Are historical stage records useful to decrease the uncertainty of flood frequency analysis? A 200-year long case study

Peer Review for Journal of Hydrology - Manuscript ID HYDROL50412

Response of the authors

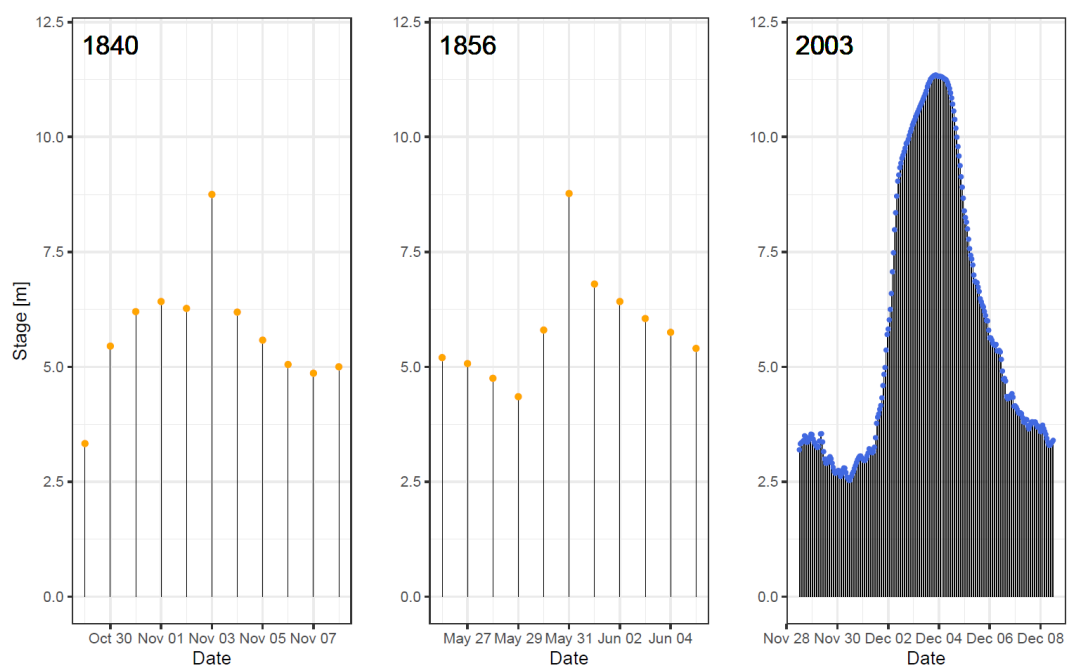
Could enhance information from fig 5 with supplementary information showing the stage observations/measurements for the 1840, 1856 and 2003 floods.

[See the following figure added in supplementary material.](#)

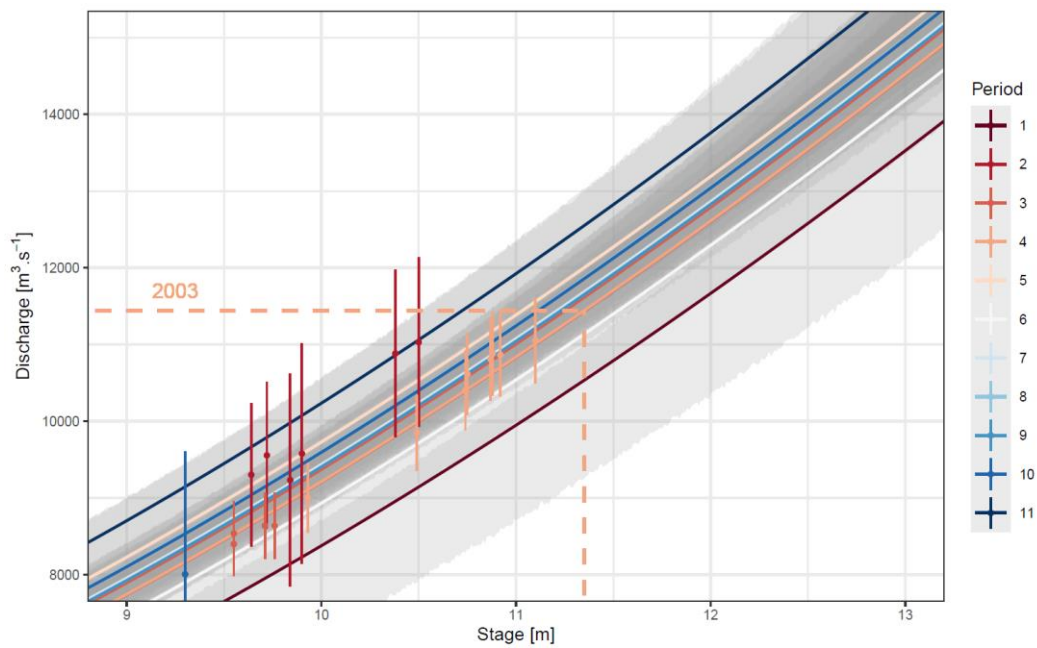
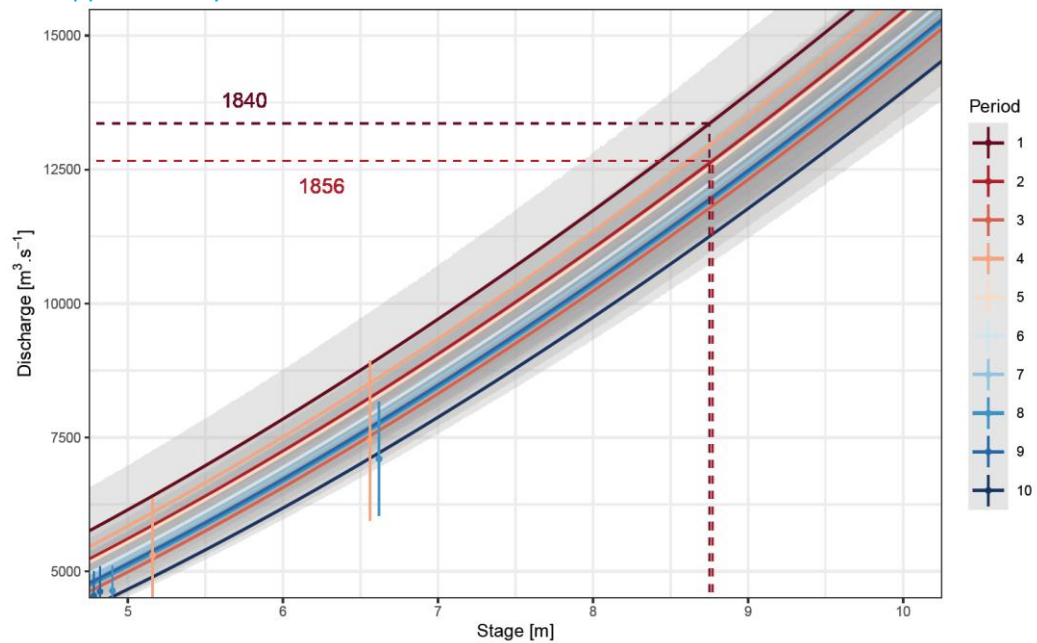
Yes. Figures 1 and 5-10 are excellent. Fig 7 b could be improved (via supplemental figure) to show a zoom in to the high-flow measurements, number of measurements, and estimated uncertainty for stage > 8.0 m (floodplain) and flow measurements > ~ 9,000 cms.

See the two following figures, for Pont de Beaucaire and Beaucaire Restitution gauges, added in supplementary material

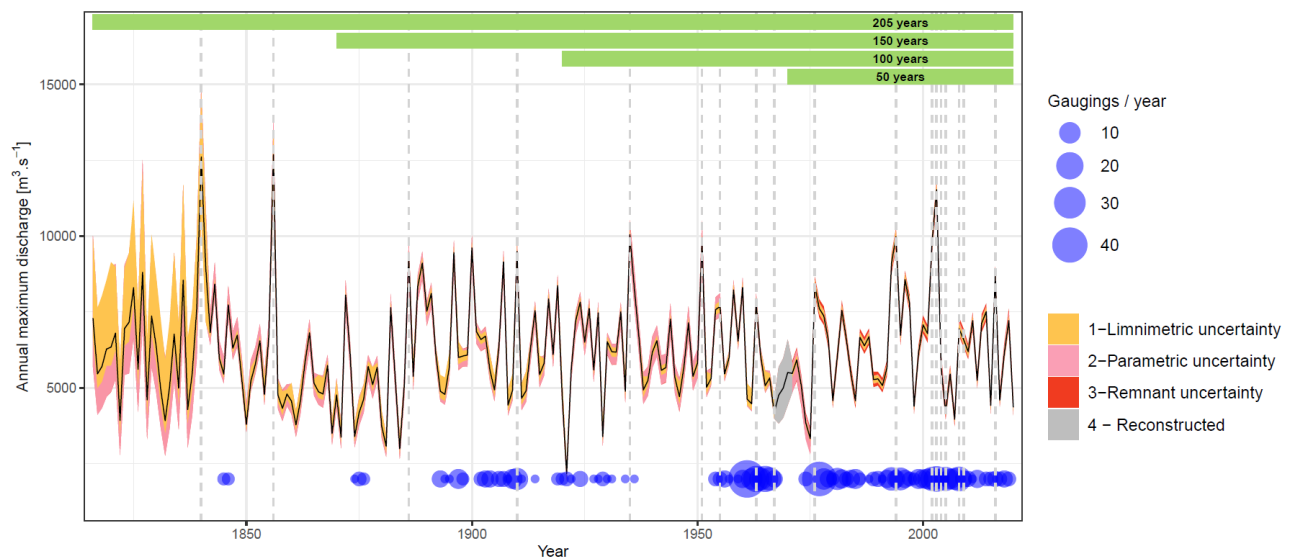
Show (could be supplementary material) a maxpost (with uncertainty) annual maximum flow time series plot for the entire period. Illustrate (vertical lines) the 50, 100, 150, and 205 year time slices from 2020. This way the reader can easily see in a figure that the < 205 year time series excludes the 2 largest floods. This is needed to support the statements in Section 5.1. A person affected by the 2003 flood should not have been surprised, given the prior flood history in the 1800s.

[We added the following figure in Supplementary material and a sentence after line 479 \(section 4.4\) : "An AMAX flow \(with uncertainties\) time series plot is available in supplementary material".](#)
